## Meeting Summary

### Section 1 Kennedy Interchange Area Advisory Team Meeting No. 5 October 26, 2006

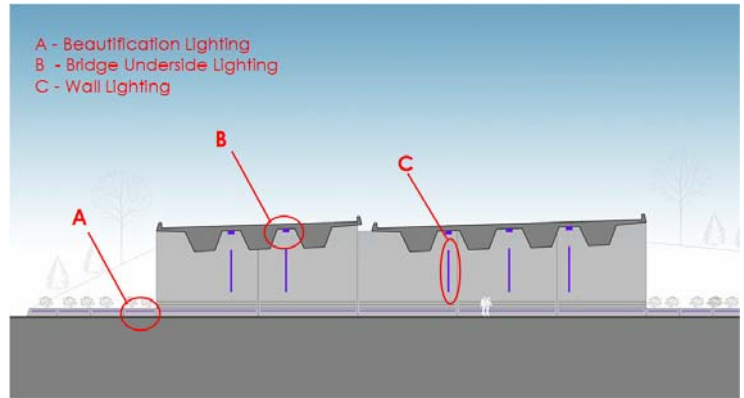
8C. The sidewalks on Main and Market should be larger than currently proposed (15' minimum width should be considered) and the sloped abutment walls should be made vertical. This will allow those gateways to serve as gathering areas with displays of public art. The lighting could be designed to accommodate paintings/murals on the abutment walls by "framing" the paintings; the wider sidewalks will provide both gallery viewing areas and adequate space for pedestrian travel.
